TRACKSIDE GARDENS

WILSON EAST

Town Planning Application - RFI Response

Project Name 110 Wilson Street
Project Number 00013261
Project Address 110 Wilson Street
Moonee Ponds VIC 3039

Drawing Name
**WILSON EAST
Basement 01 Plan**

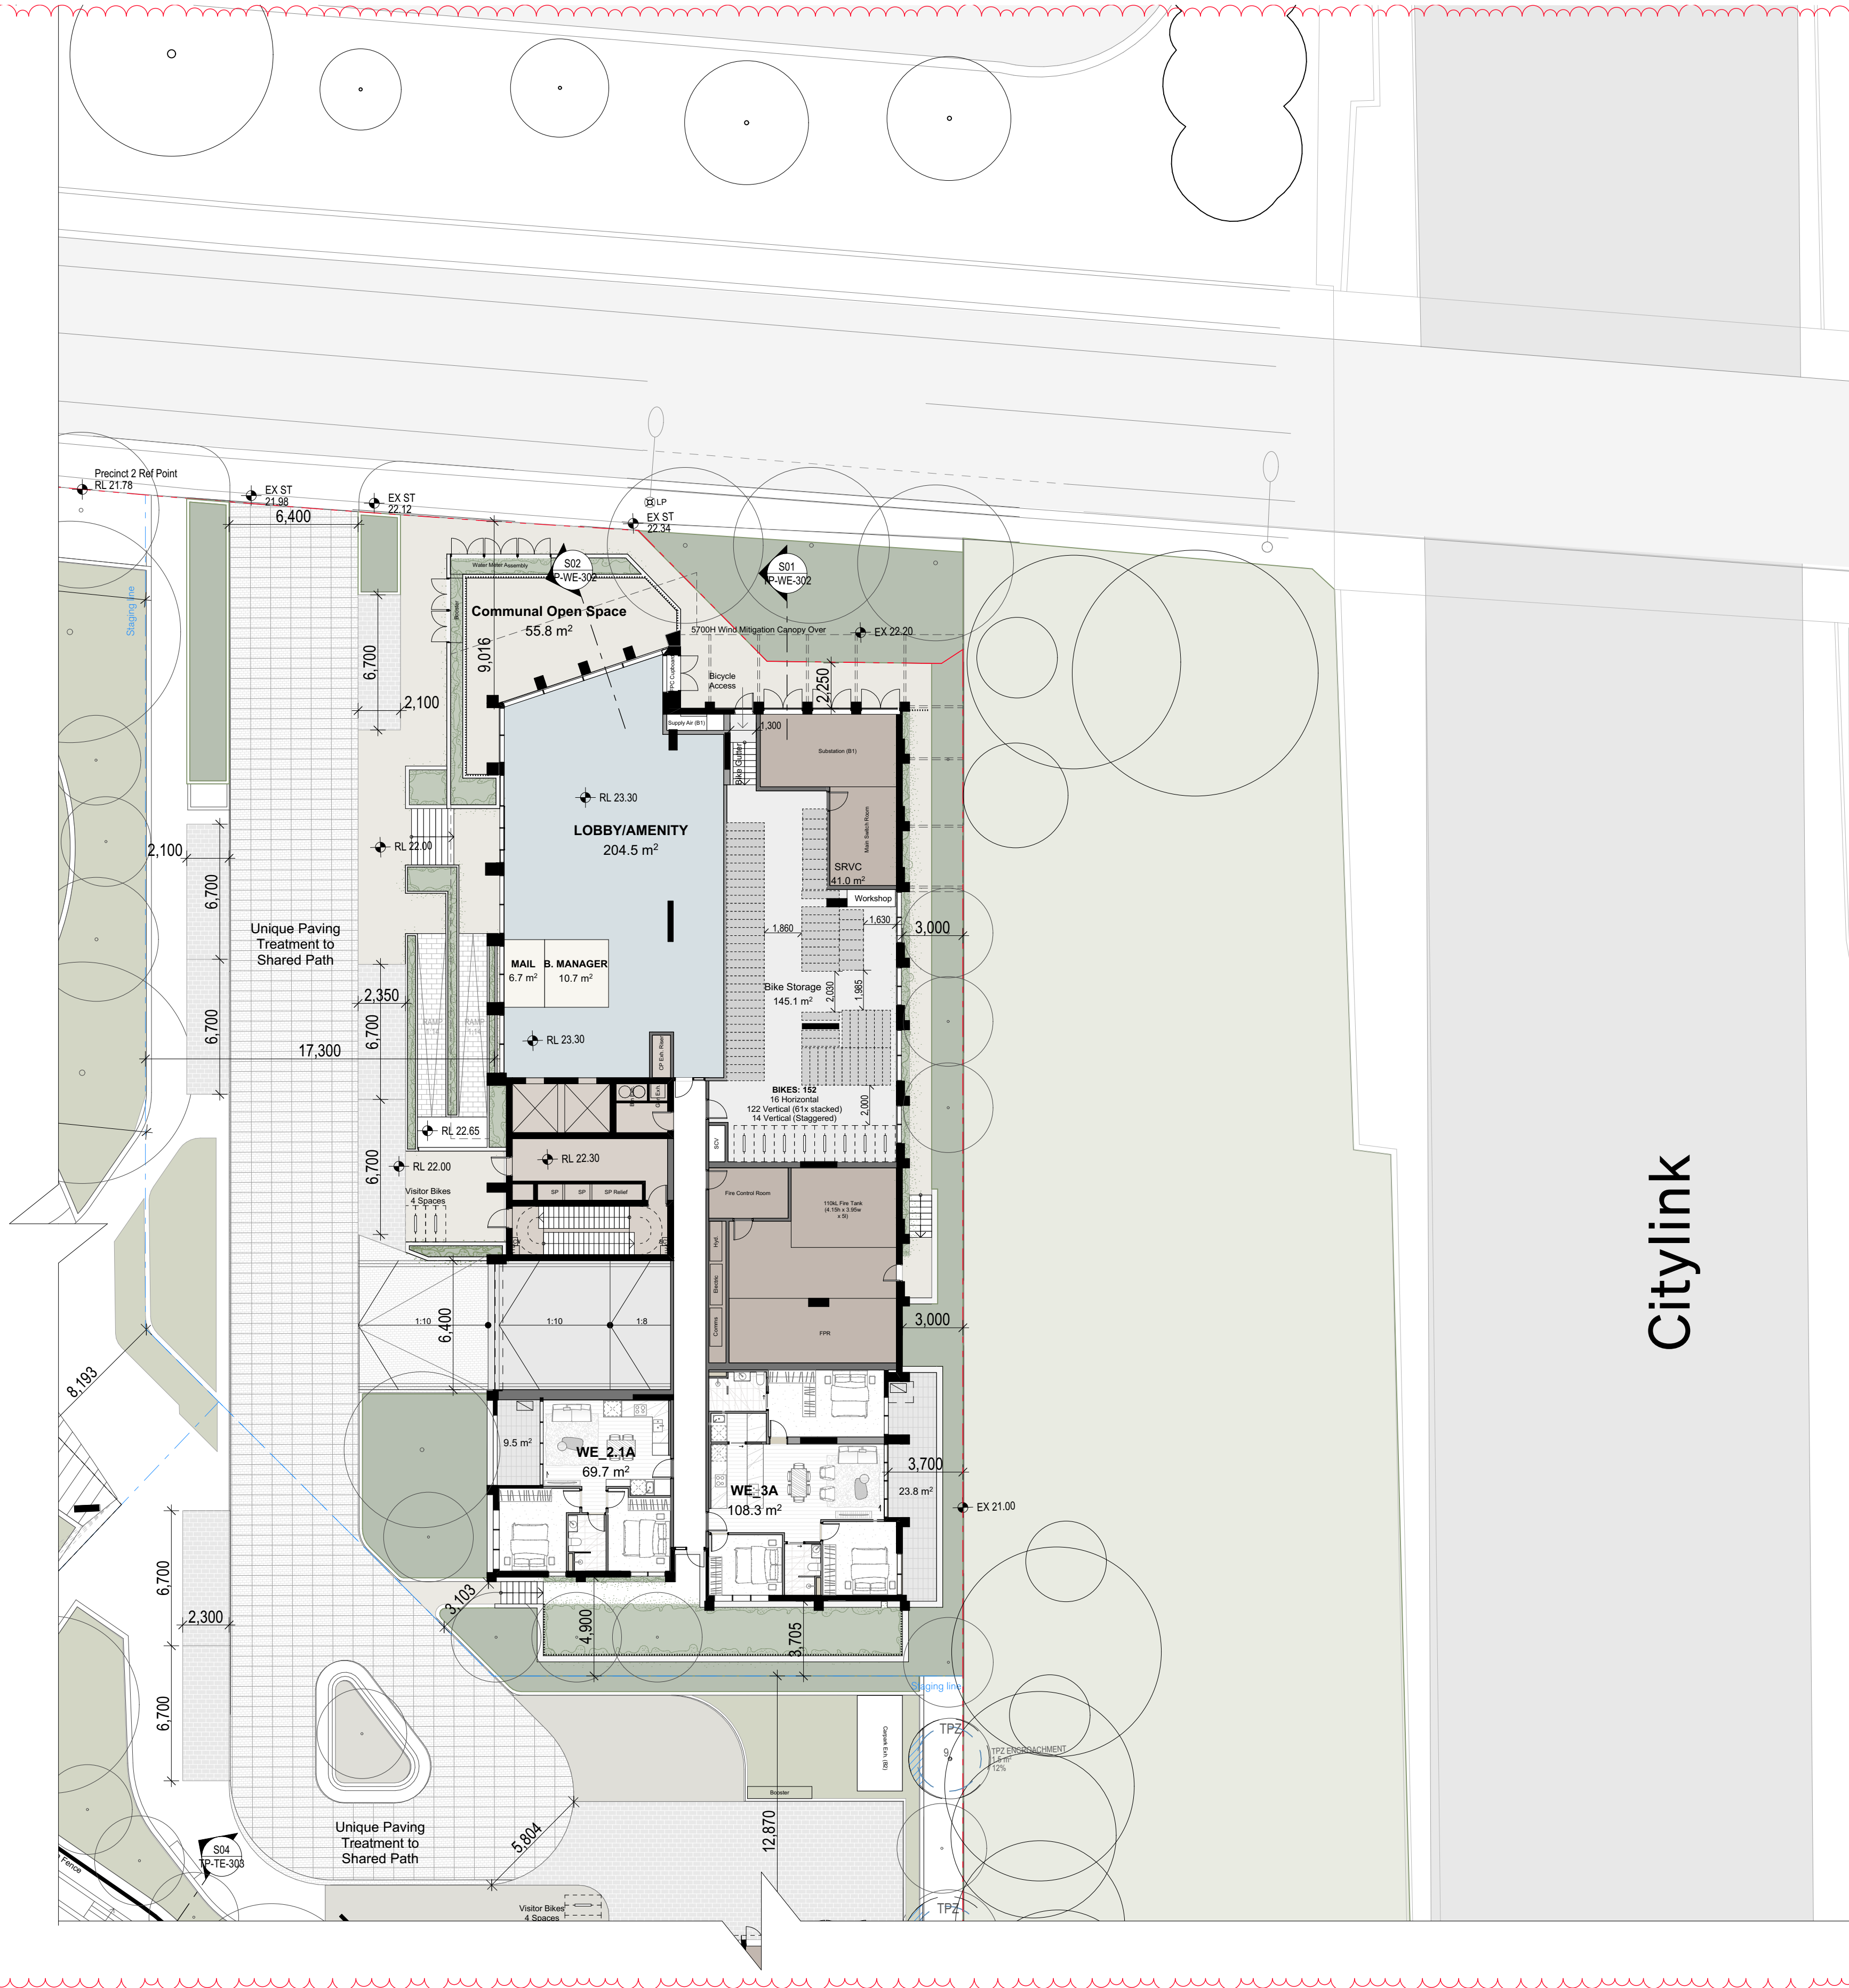
4. c). All recommendations/building performance solutions required by the Sustainability Management Plan, particularly those that will impact the appearance of the façade.

Drawing Name
WILSON EAST
Upper Ground Plan

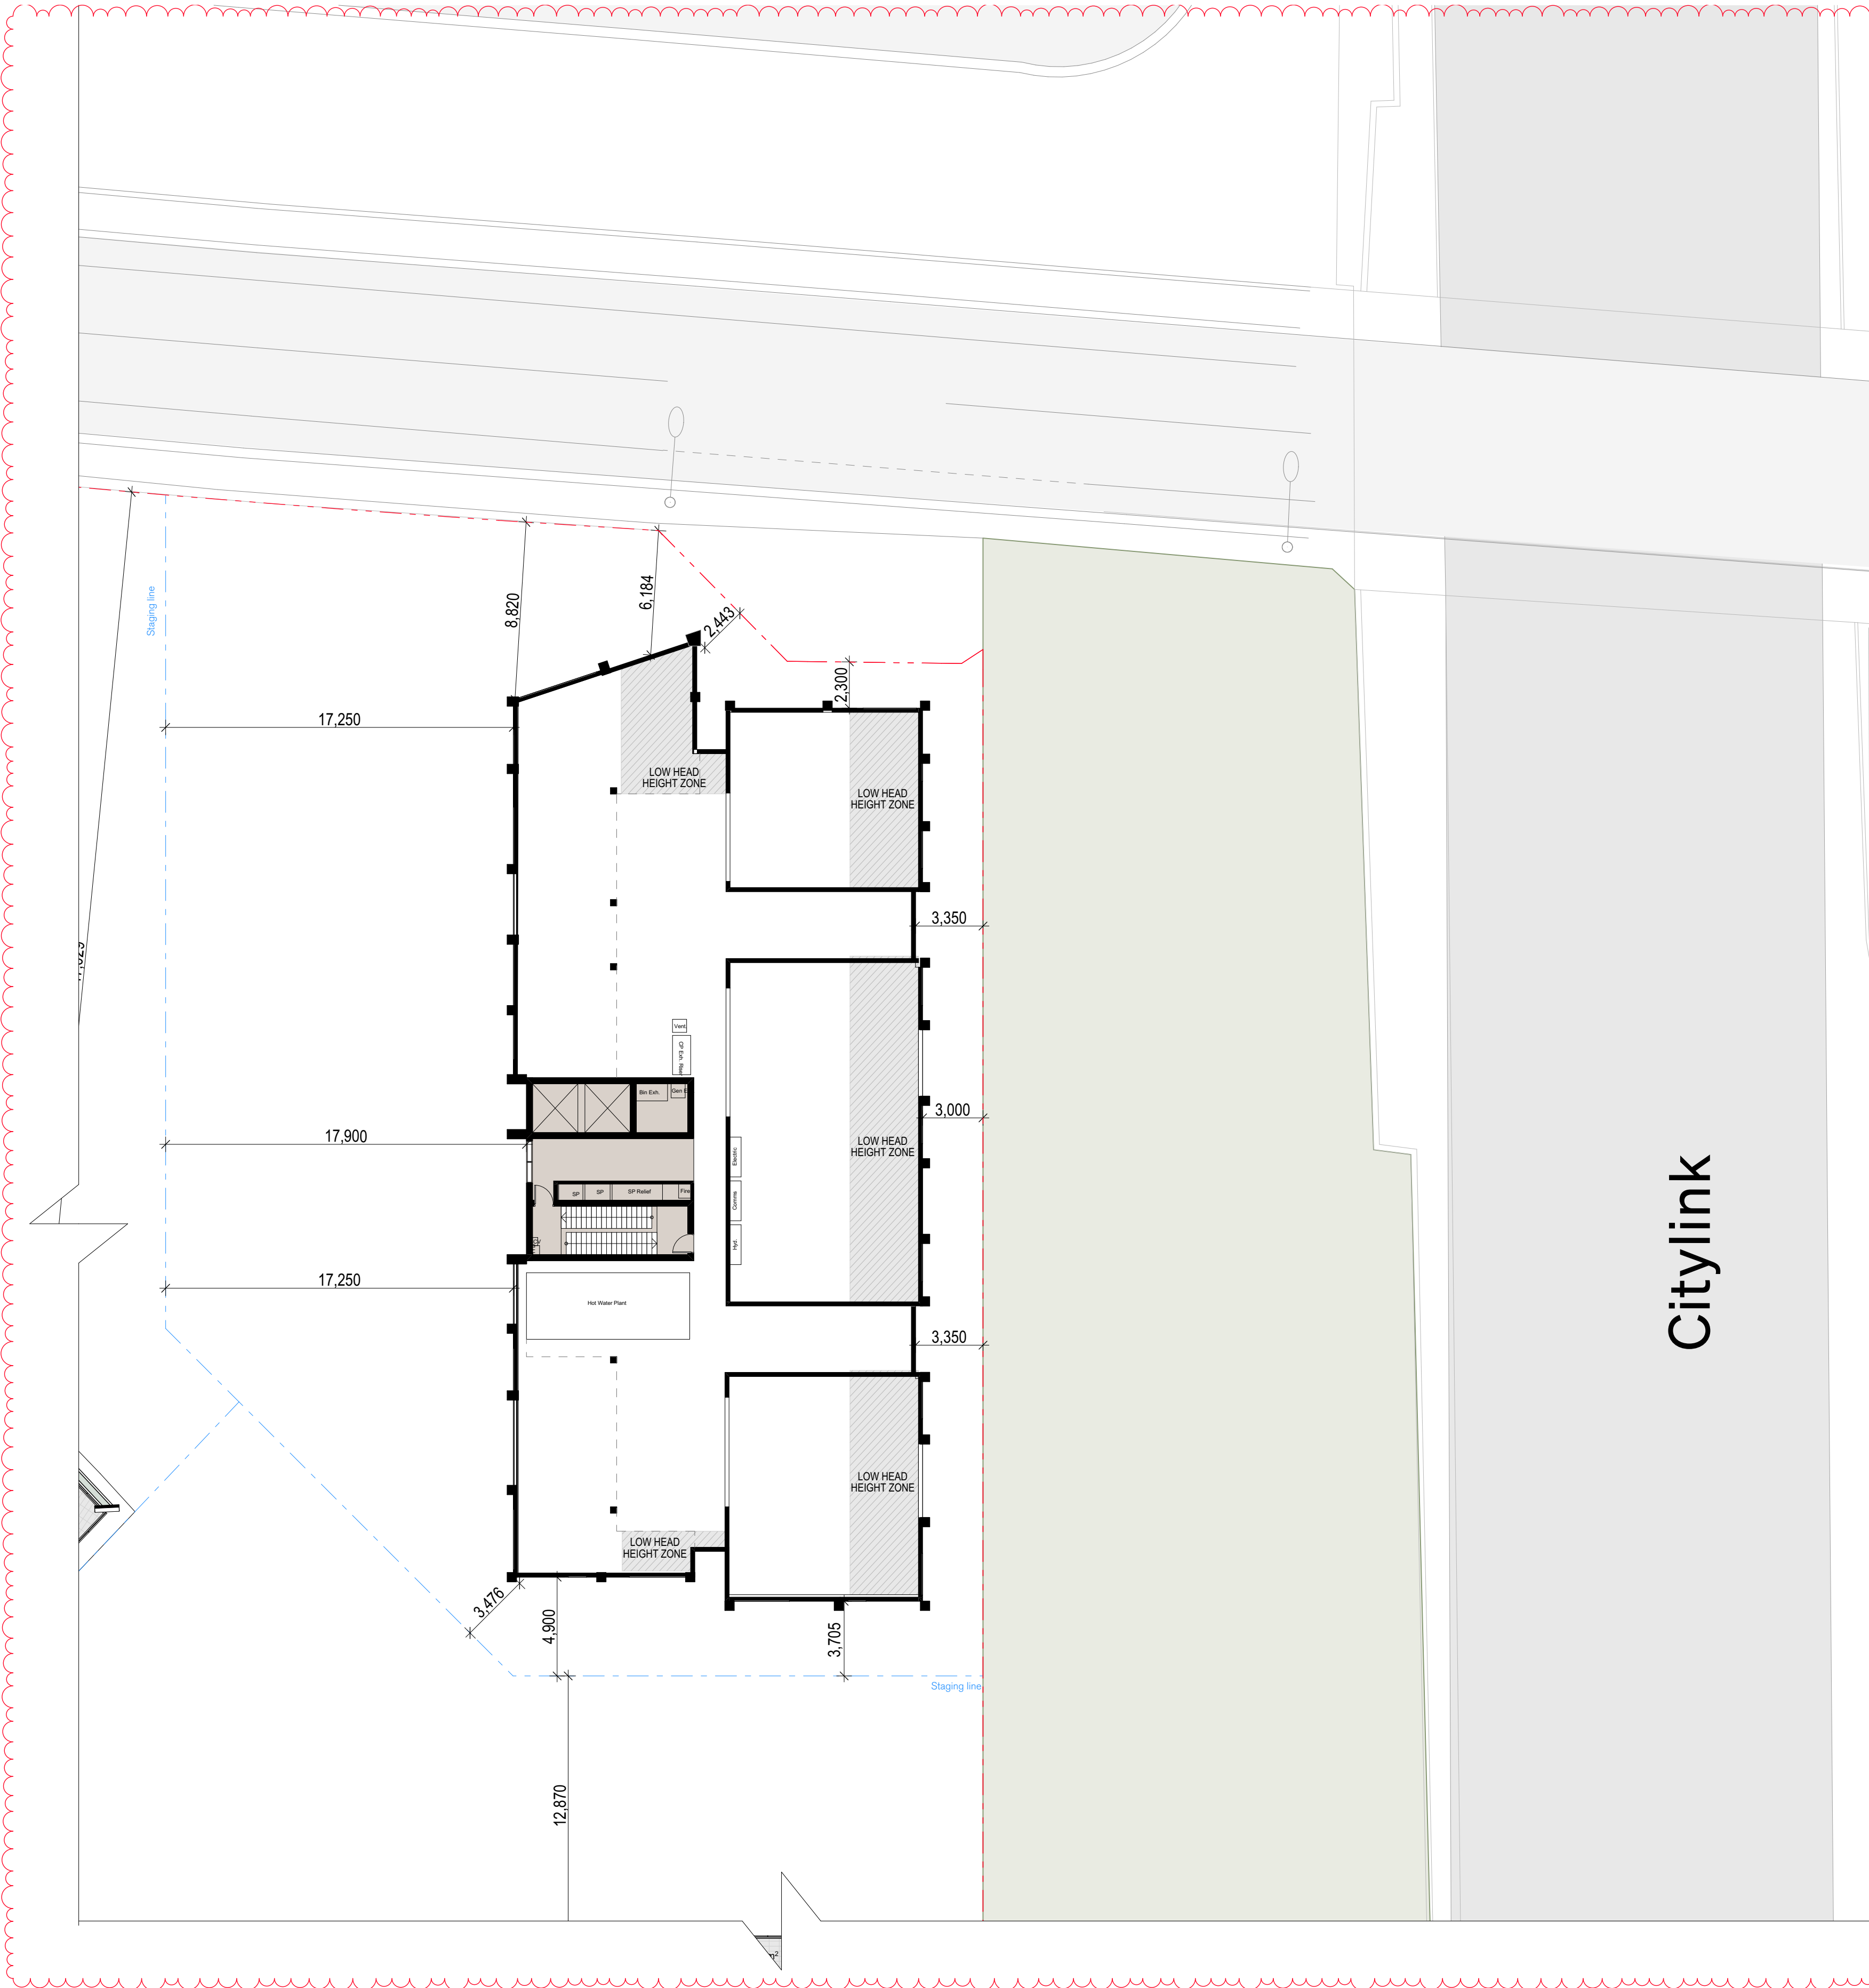
4. c). All recommendations/building performance solutions required by the Sustainability Management Plan, particularly those that will impact the appearance of the façade.

Drawing Name
WILSON EAST
North & West Elevation

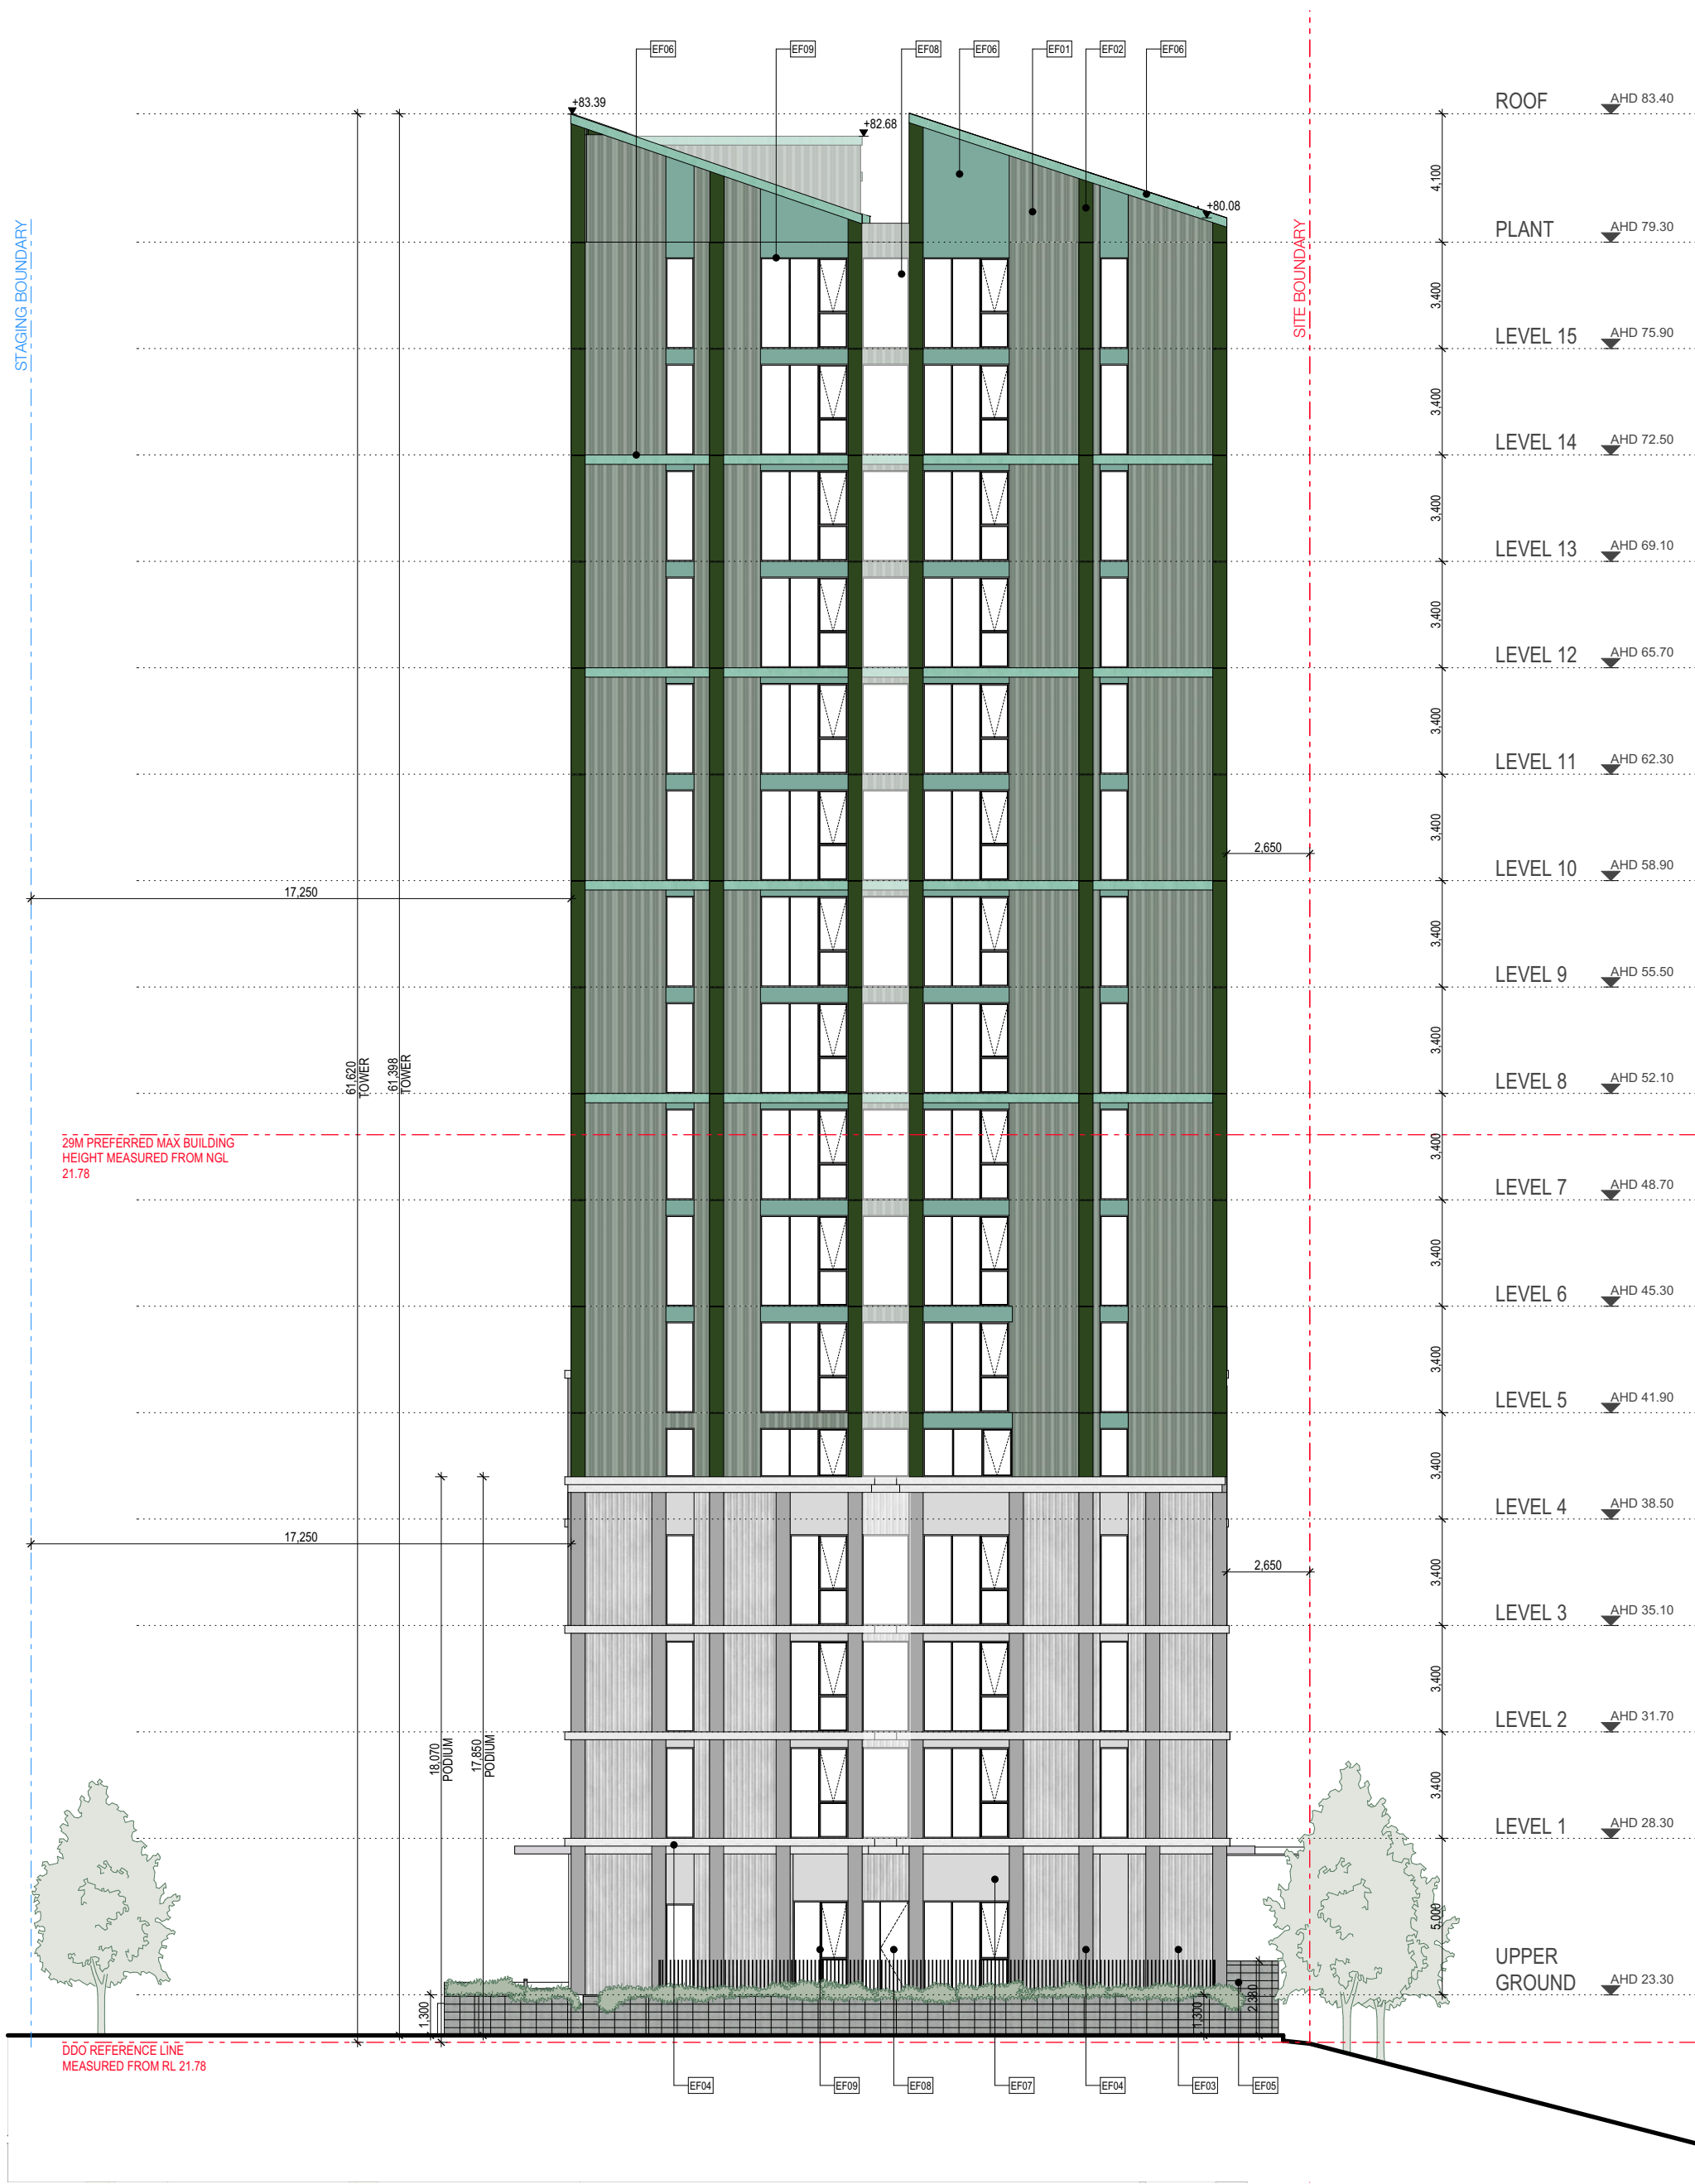
PA2604323 SECTION 54(1) RPI MATTERS
4. All recommendations/building performance solutions required by the Sustainability Management Plan, particularly those that will impact the appearance of the façade.
1) The outline of the DDO12 preferred building setbacks on sections/elevations.
Urban Design Advice.
Less permeable crown expression to truly convey their character.
